Historical Architectural Review Board
COA Preliminary Review Sheet

HDC-2025-00033

Address: 806 Monroe Street

Proposal: Infill door opening and re-stucco first floor and side.

Monroe Street Elevation, April 2024 (Google Maps)

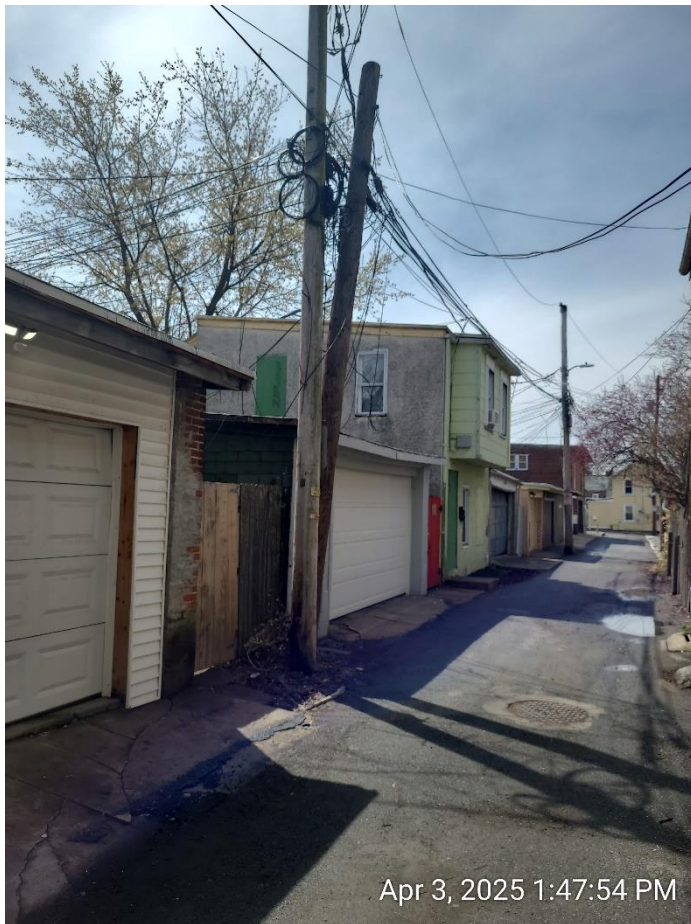
5/5/25 Observations & Comments: Infilling a doorway on a primary façade is not appropriate, as entry doors contribute to the composition of the primary façade. Removing a point of building egress may require approval by the Bureau of Building Standards and Safety, separate from HARB review. More information would be helpful to understand why door infill is the proposed solution; have other options been explored to maintain a secure entry?

Maintaining the stucco on the exterior walls of the building is appropriate; based on available imagery, the stucco has been in place since before 2008.

The application states the possibility of installing shutters along the Monroe Street elevation. More information would be required to review this item, such as evidence that shutters historically existed on the building. Refer to Guideline 3.5.21.

Staff Recommendation: Staff recommend denying.

Proposed Door Infill Area (City of Allentown)

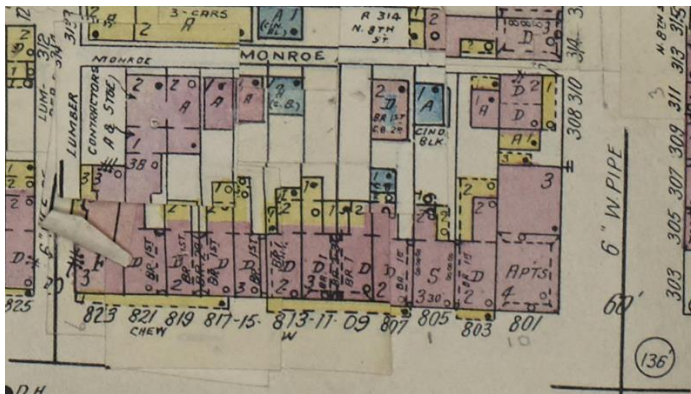
1. Door (facing Monroe St): The door was within a 30” opening and was removed and framed using a double 2x4 header and 3-2x4 studs. The opening was insulated and covered with ¾” ZIP plywood panel, and will be finished with mesh wire and stucco mortar to match existing finish of rest of property.

1. If removal of the front door is acceptable to the HARB, the proposed exterior finish to match the adjacent stucco is appropriate.
2. Maintaining the existing first floor window that was previously covered over is appropriate. All visible windows appear to be vinyl replacement windows. While new vinyl windows are not appropriate per the Guidelines, 3.5.12 states “If replacing a single window on a façade, replicate the existing windows of that façade.”
3. The proposed mailbox is a simple design and is appropriate.
4. Per the Guidelines, shutters should not be added where there is no evidence they existed historically. Vinyl shutters are not appropriate.

- Stucco over door infill is installed as presented.
- Mailboxes are installed as presented.
- Shutters are not installed.

- Stucco over door infill is installed as presented.
- Mailboxes are installed as presented.
- Shutters are not installed.
- Stoop Monroe Street is removed.
